Range SA Large Regional - Ho.Re.Ca.	Model 9100 – 95 – Krea Touch	N° T.I. 04_2024
Serial Number See page 2 / 2	Subject <b>NEW PISTON ASSEMBLY Z4000 ES/FB</b>

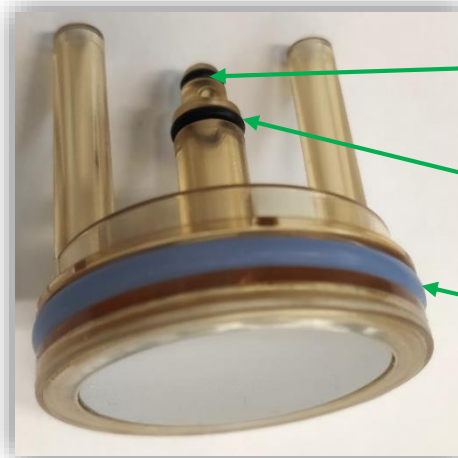
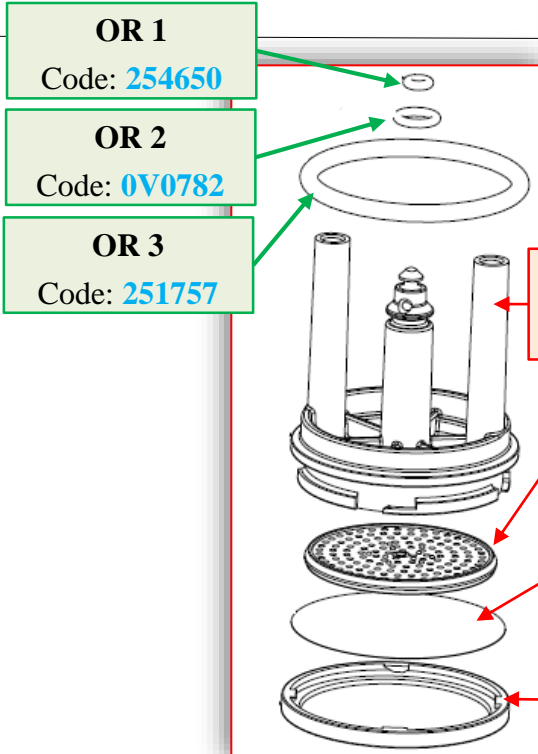
**Pre – modified ES/FB Z4000 upper piston** assembly has been replaced by **new "ESFB Z4000 welded piston assembly + three O-Rings"**.

For the **new upper piston** assembly the filter is welded to the piston.

This ensures that the filter lasts for a greater number of strokes.

The **three O-Rings 1, 2, 3** can be ordered individually

**New ESFB Z4000 welded piston assembly + three O-Rings** Spare code:  
**266009/sap 55127649**

- OR 1**  
Code: **254650**
- OR 2**  
Code: **0V0782**
- OR 3**  
Code: **251757**

- ES/FB Z4000 upper piston**  
Code: **260204**
- ES/FB filter support**  
Code: **256753**
- ES/FB coffee filter**  
Code: **256737**
- Fastening filter ring nut**  
Code: **256754**
